**MEETING OF THE
PLANNING AND ZONING BOARD
QUASI-JUDICIAL PUBLIC HEARING**

May 21, 2019

**TOWN OF BAY HARBOR ISLANDS
DRC STAFF
PLAN REVIEW**

**RE: BELIZA 1170 102 STREET
RESPONSE TO COMMENTS BY MICHAEL MILLER PLANNING ASSOCIATES, INC.**

P & Z PROPOSED REVISION

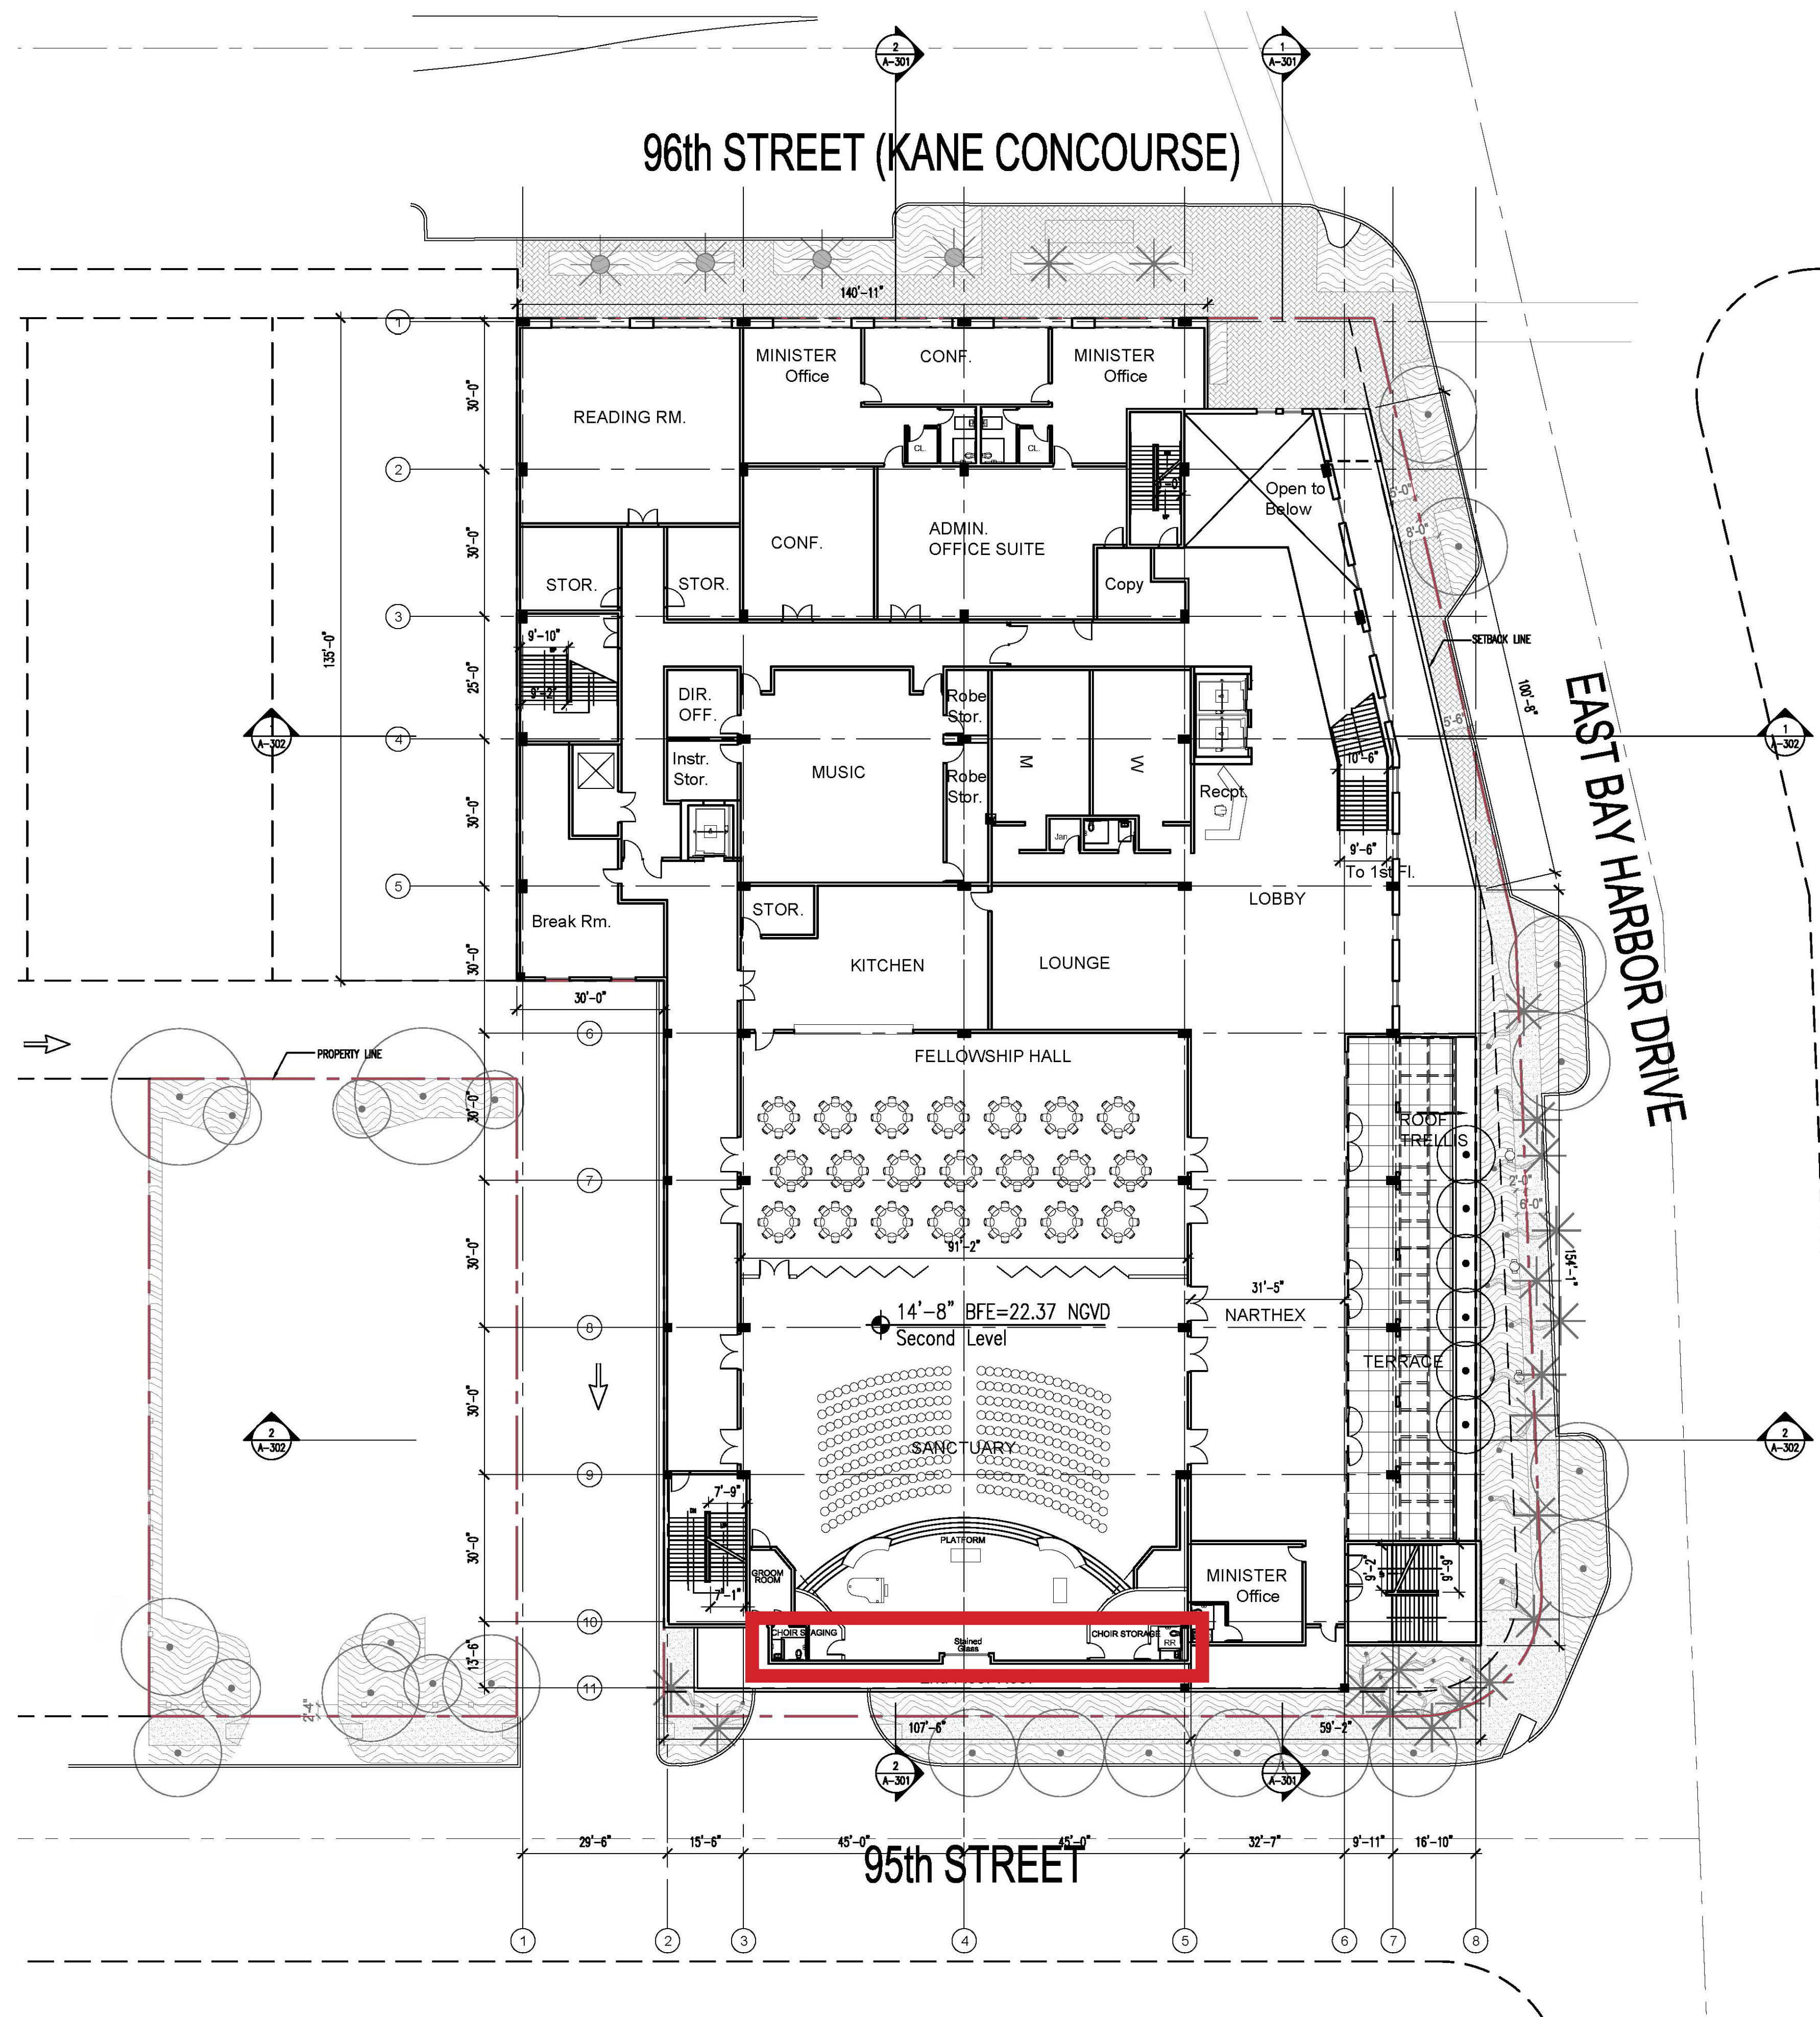
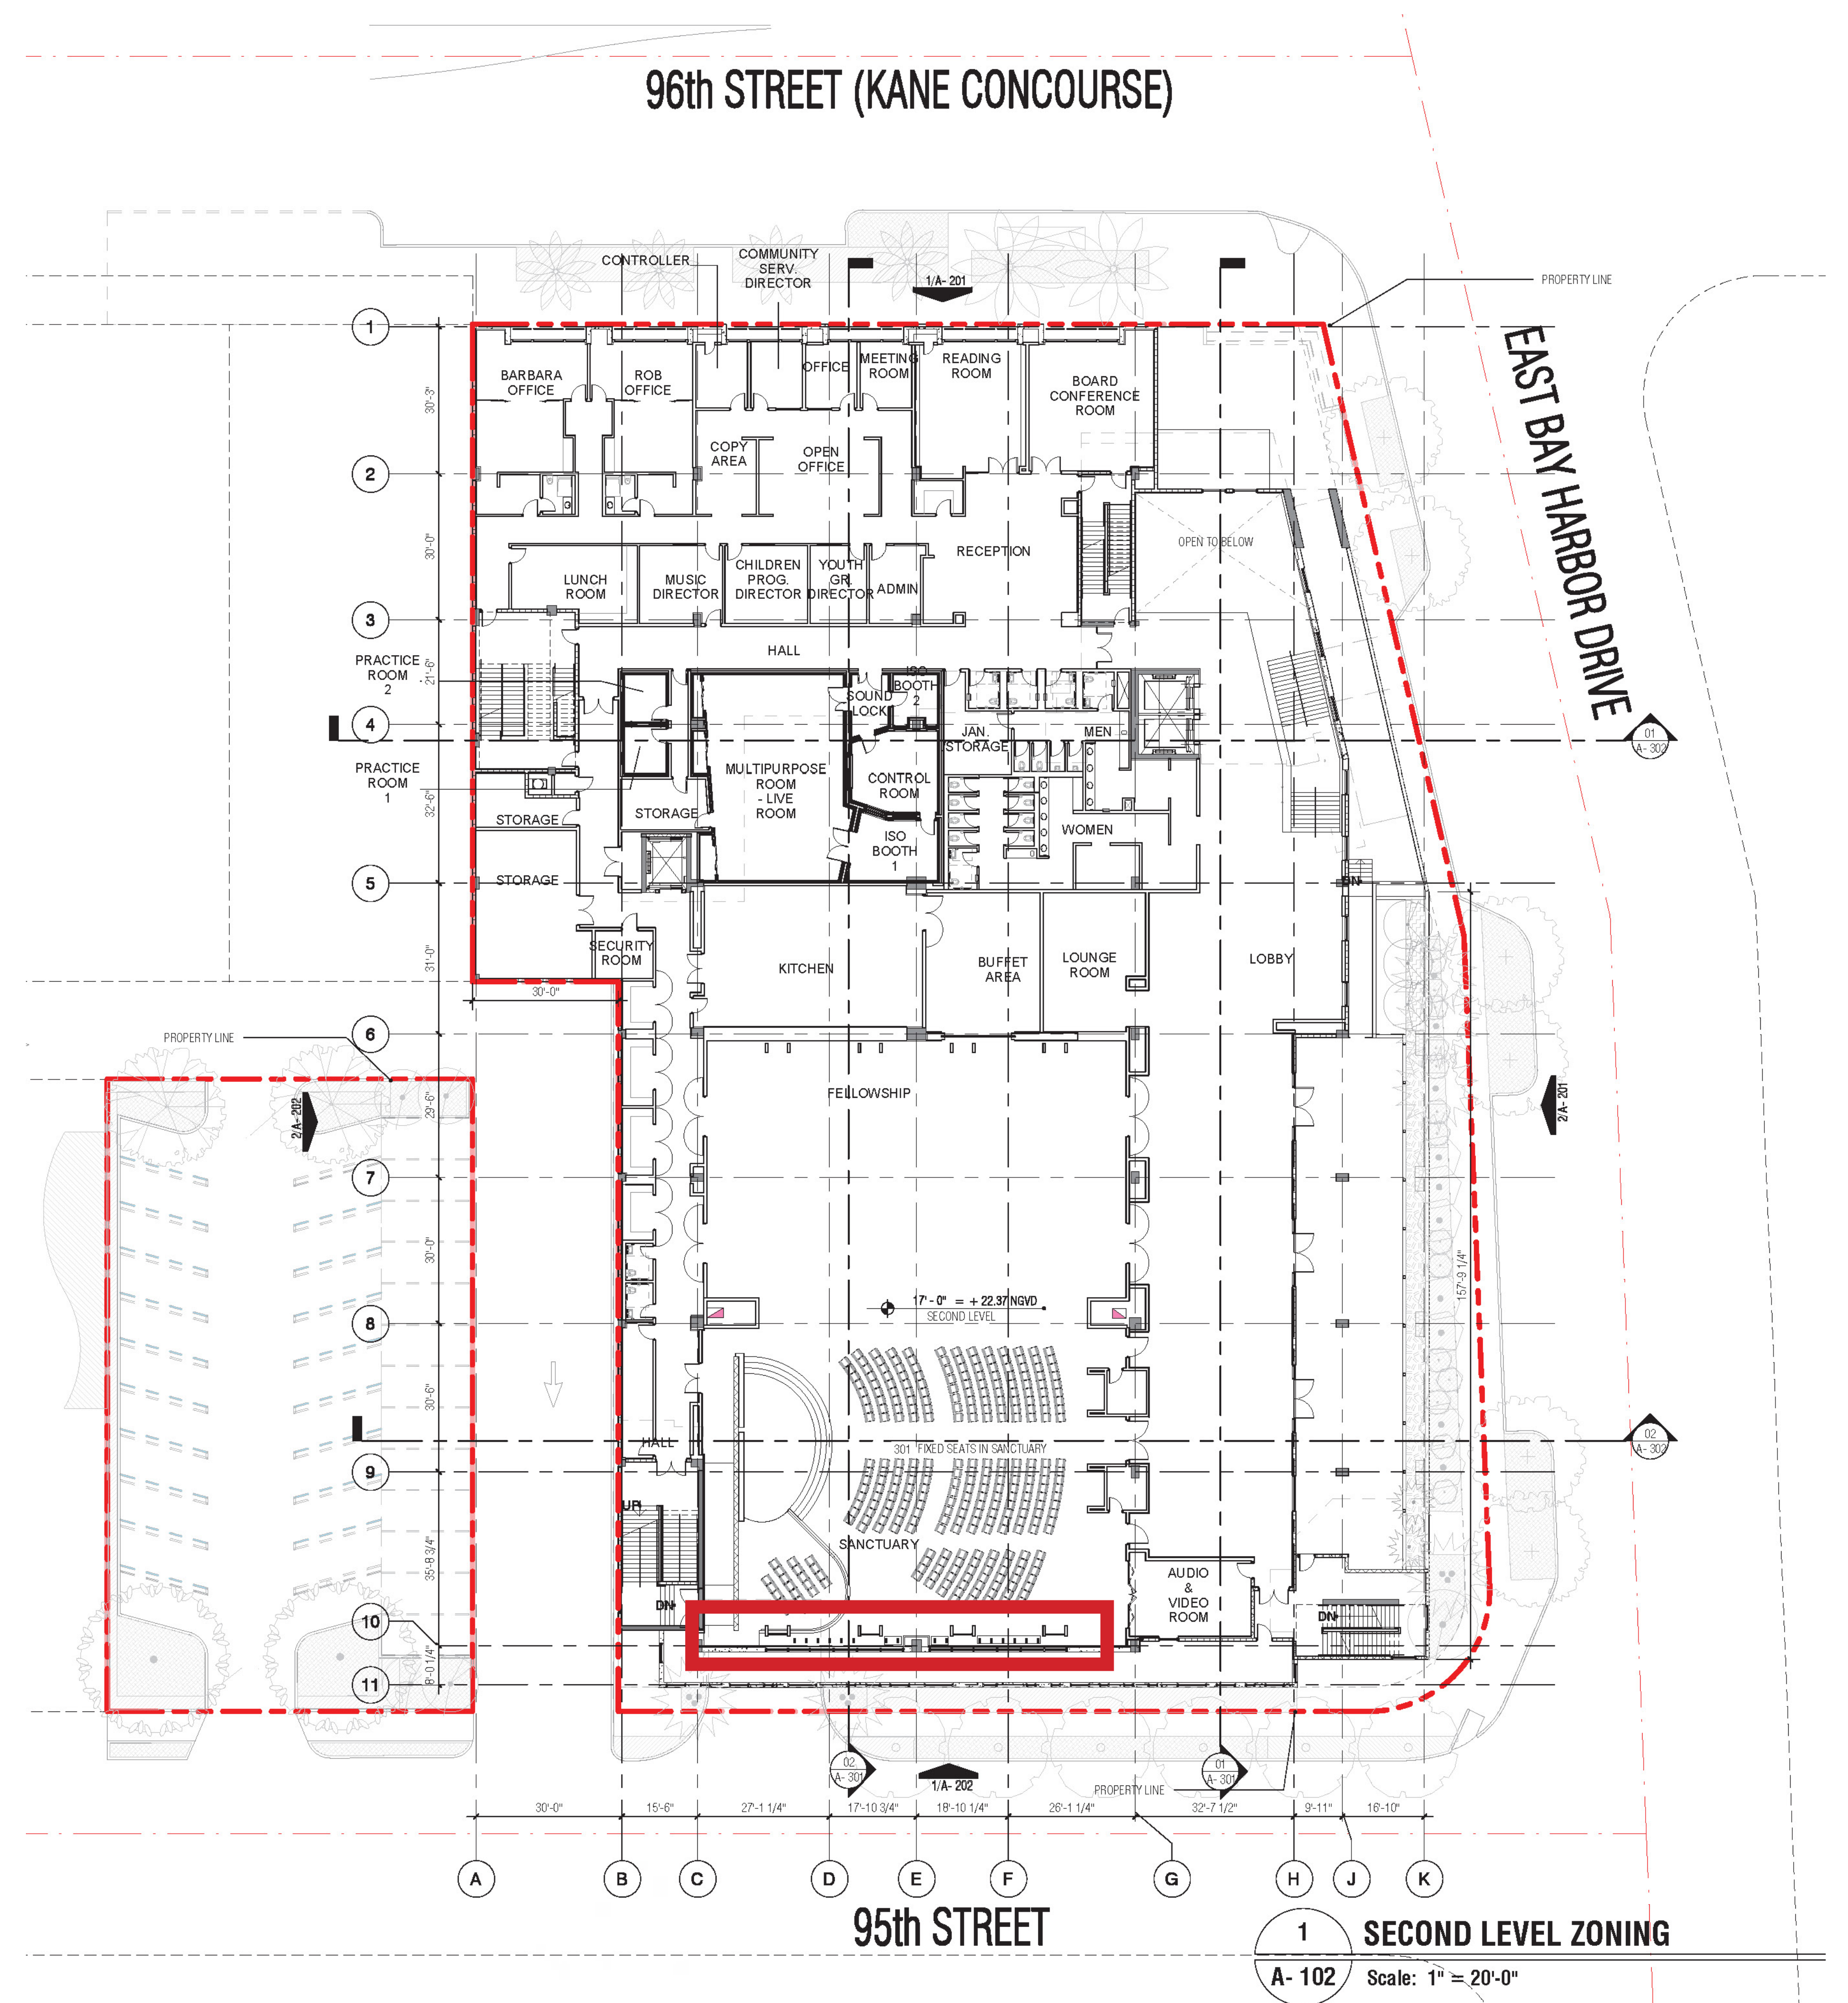
SANCTUARY SOUTH WALL MOVED BACK 1'-7" TOWARDS THE NORTH; INTERIOR MODIFICATIONS ONLY
